Public Input No. 107-NFPA 70-2025 [Global Input]

Committee: NEC-P10

Figure 1 - Up to 20mA of current allowed to flow on the equipment grounding conductor

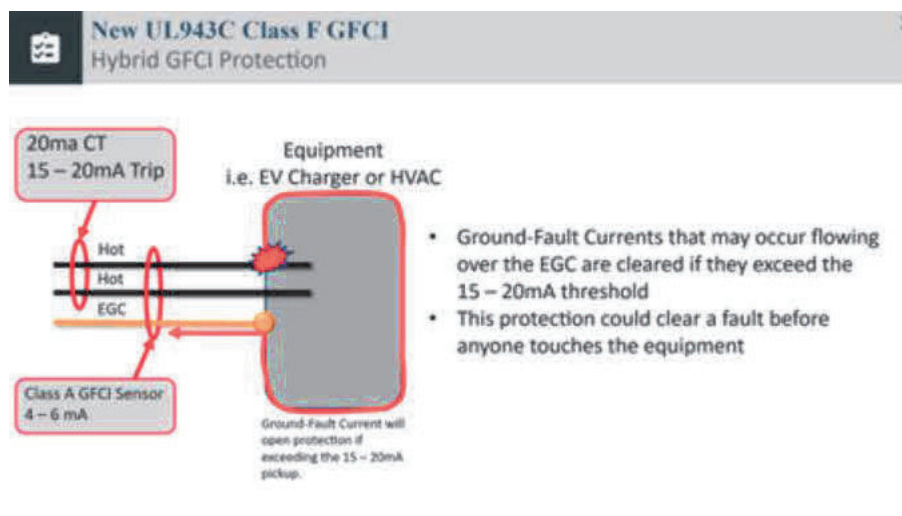
A new Class F GFCI requirements in UL943C allow up to 20 mA to flow on the equipment grounding conductor while providing Class A protection where current flows through a path other than the equipment grounding conductor – see figures 1 and 2.

Figure 3 - GFCI protection level on the EGC is the same as the protection provided by EVSE

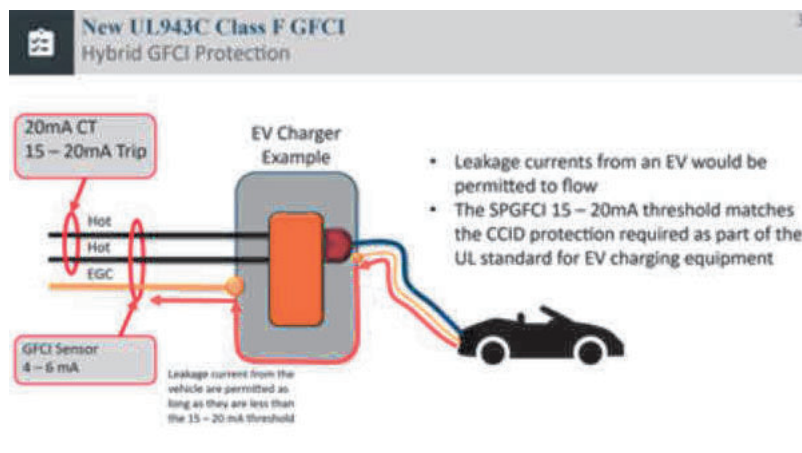
The equipment grounding conductor GFCI level is set at 20mA max and is a hybrid solution intended to be tuned to applications where leakage current on the EGC is necessary for operation – see figure 3

Figure 4 - Class F will provide protection all the way down to the vehicle

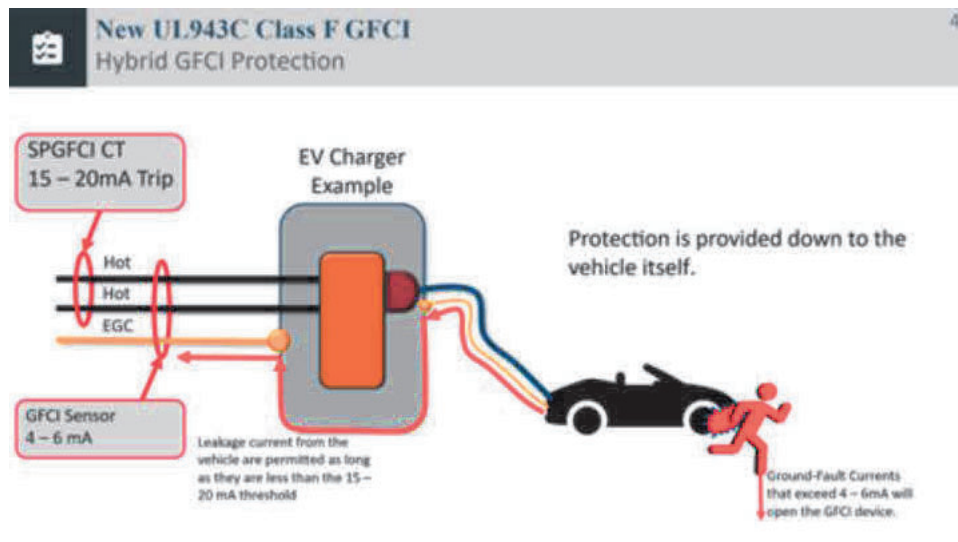
In addition, it protects the entire circuit all the way down to the connected load – a major advantage over the current equipment protection (I.e EV Charging in UL2231) which only protects downstream from the equipment – see figure 4

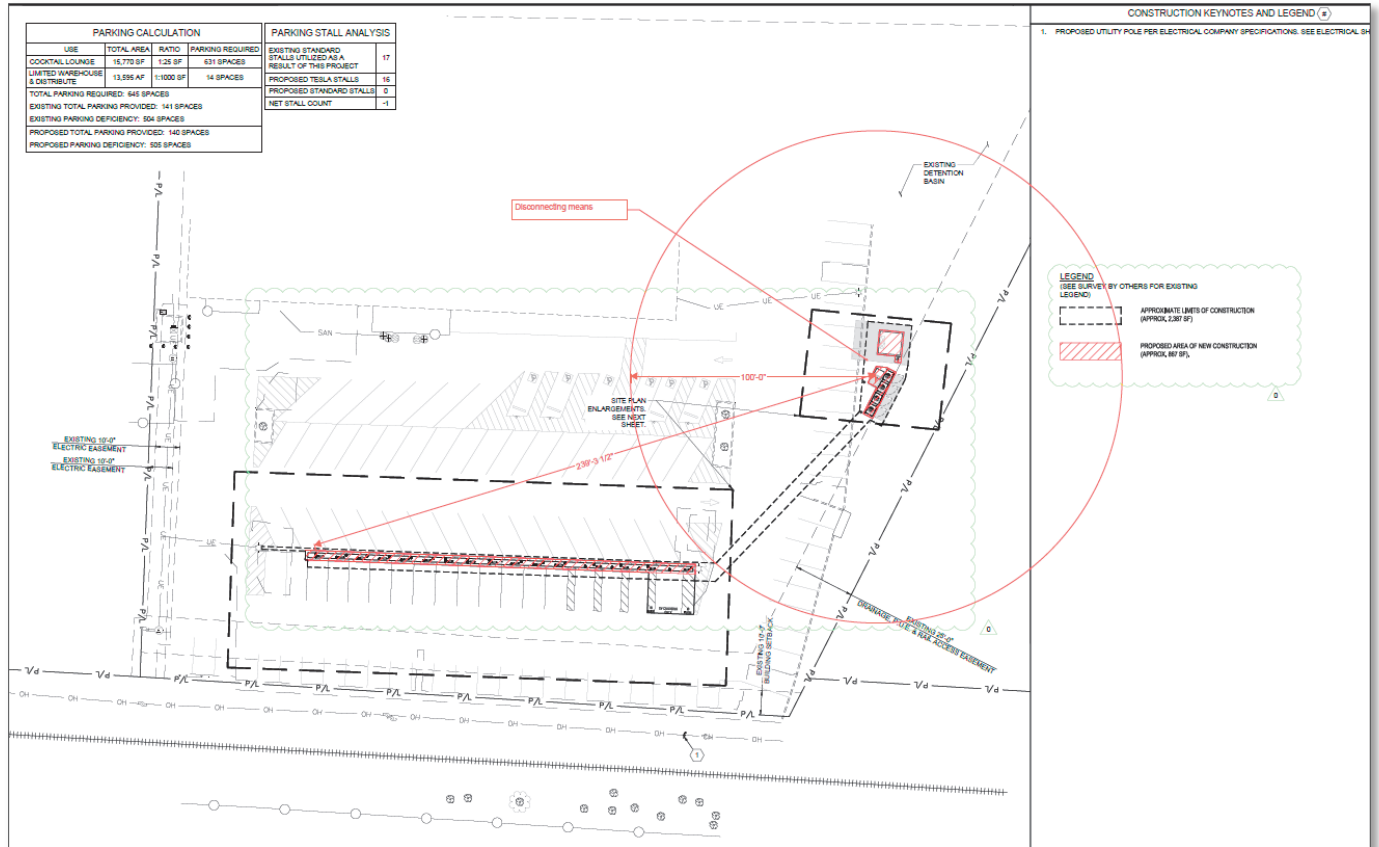
The intent of this section is to provide an easily identifiable shutdown device for first responders when onsite at an EV charging site. The core needs to meet this intent of first responders include

- Location identification of the emergency shutdown devices at a common point across sites
- Devices must be readily accessible and outdoors (ideally at a standardized point across sites)
- Location flexibility based on AHJ official preference and atypical site considerations
- Safe, reliable, and familiar devices to initiate the emergency shutdown function
- Standardized and secure (lockable) operation of the device
- Labeling of the device and other appropriate warnings

This public input provides language that would eliminate the problems the current language creates and ensures EV charging sites will meet the needs of first responder emergency shutdown.

Figure 1 - Up to 20mA of current allowed to flow on the equipment grounding conductor

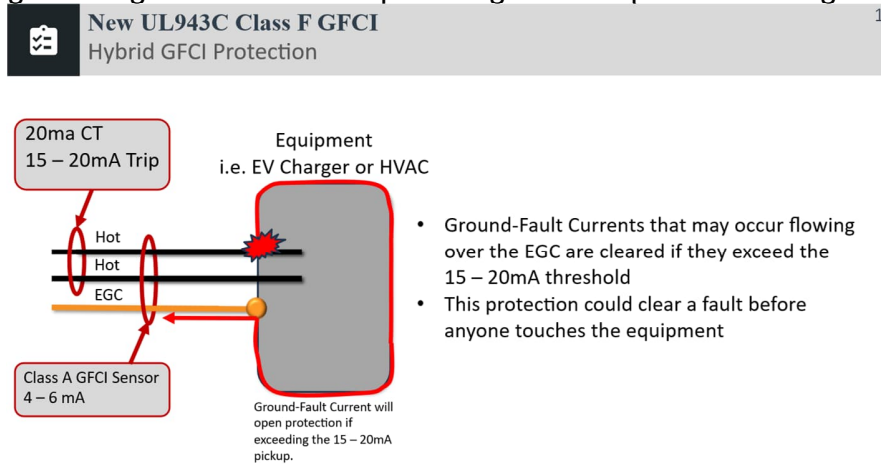
Last cycle since GFCI protection for hardwired Electric vehicle chargers (EVSE) was removed by appeal based on a concern from the Electric vehicle chargers (EVSE) industry regarding interoperability a new type of GFCI technology was created to address the perceived interoperability concerns. New Class F GFCI requirements in UL943C allow up to 20 mA to flow on the equipment grounding conductor while providing Class A protection on ground fault – see figures 1 and 2.

Figure 3 - GFCI protection level on the EGC is the same as the protection provided by EVSE

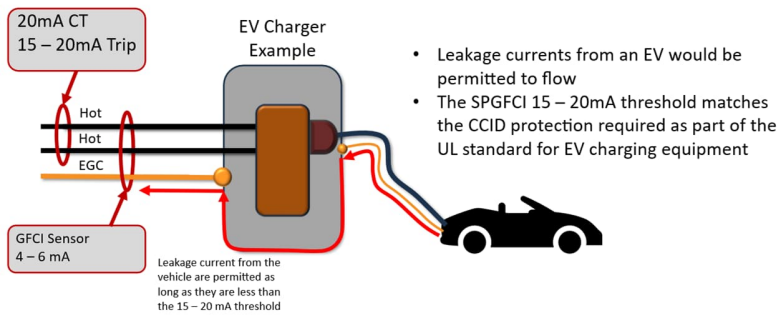
The equipment grounding conductor GFCI level is same as CCID levels in UL2231. This is hybrid solution is intended to be tuned to applications such as this – see figure 3

Figure 4 - Class F will provide protection all the way down to the vehicle

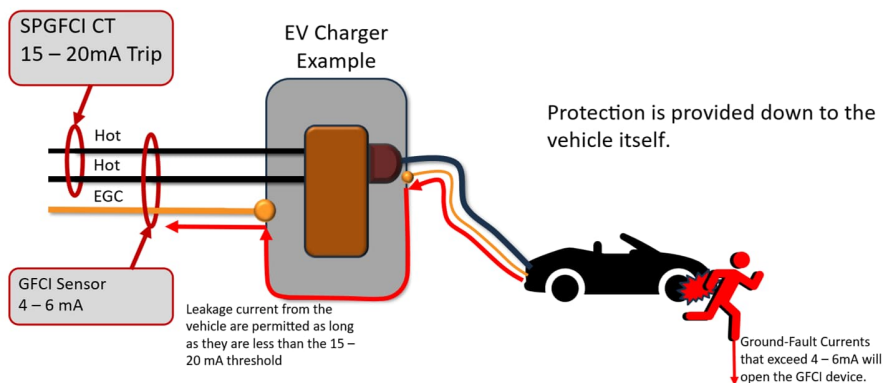
In addition, it protects the circuit all the way down to the vehicle – a major advantage over the current CCID protection in UL2231 which only protects downstream from the charger – see figure 4

Figure 1 - Up to 20mA of current allowed to flow on the equipment grounding conductor

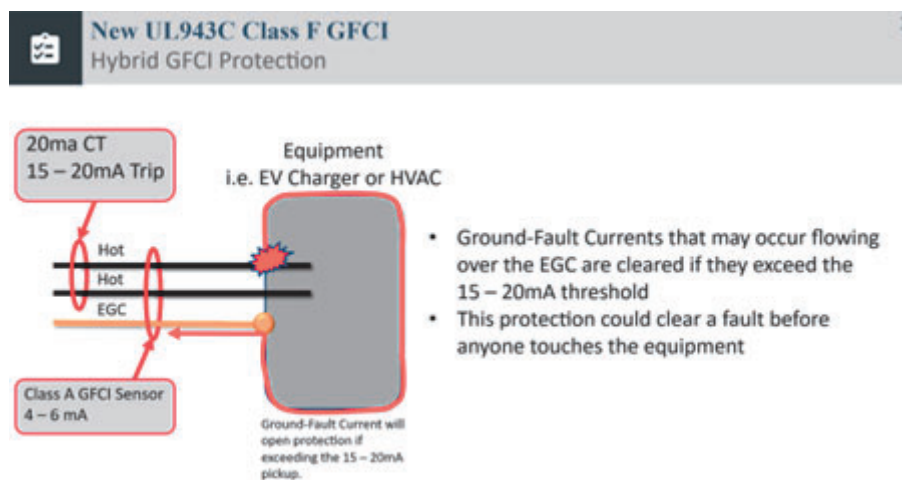
A new Class F GFCI requirements in UL943C allow up to 20 ma to flow on the equipment grounding conductor while providing Class A protection where current flows through a path other than the equipment grounding conductor – see figures 1 and 2.

Figure 3 - GFCI protection level on the EGC is the same as the protection provided by EVSE

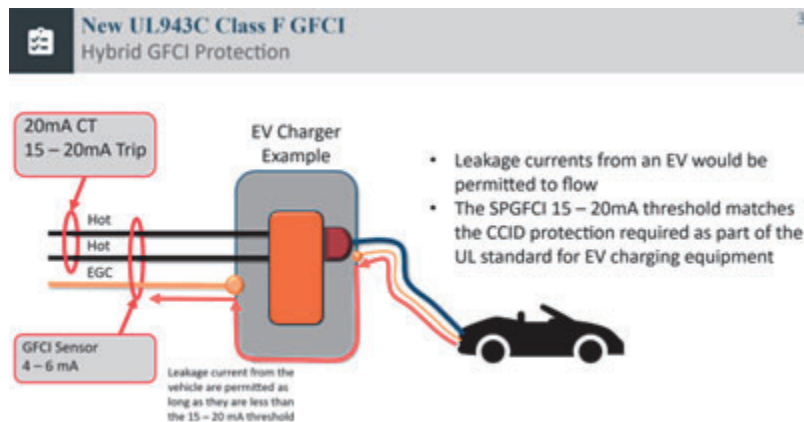
The equipment grounding conductor GFCI level is set at 20mA max and is hybrid solution intended to be tuned to applications where leakage current on the EGC is necessary for operation – see figure 3

Figure 4 - Class F will provide protection all the way down to the vehicle

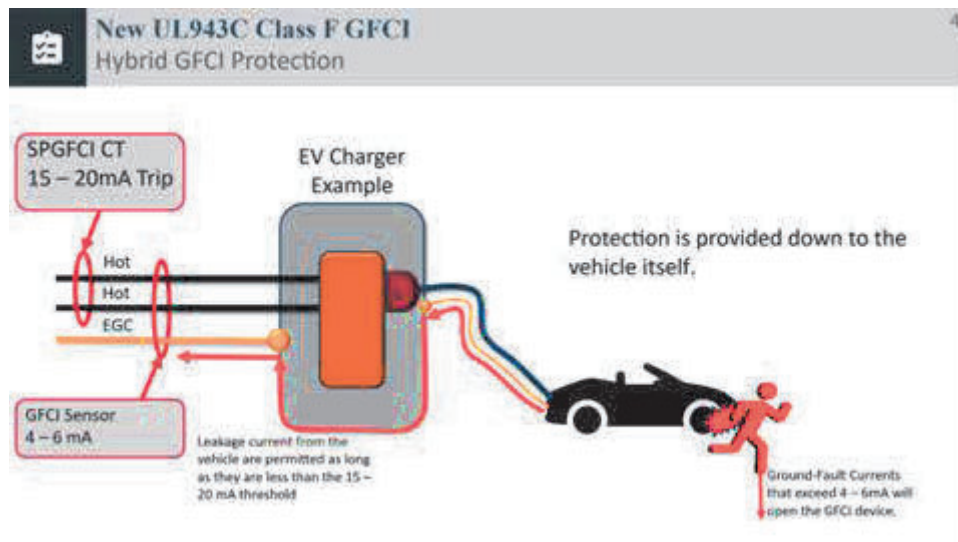
In addition, it protects the entire circuit all the way down to the connected load – a major advantage over the current equipment protection (I.e EV Charging in UL2231) which only protects downstream from the equipment – see figure 4
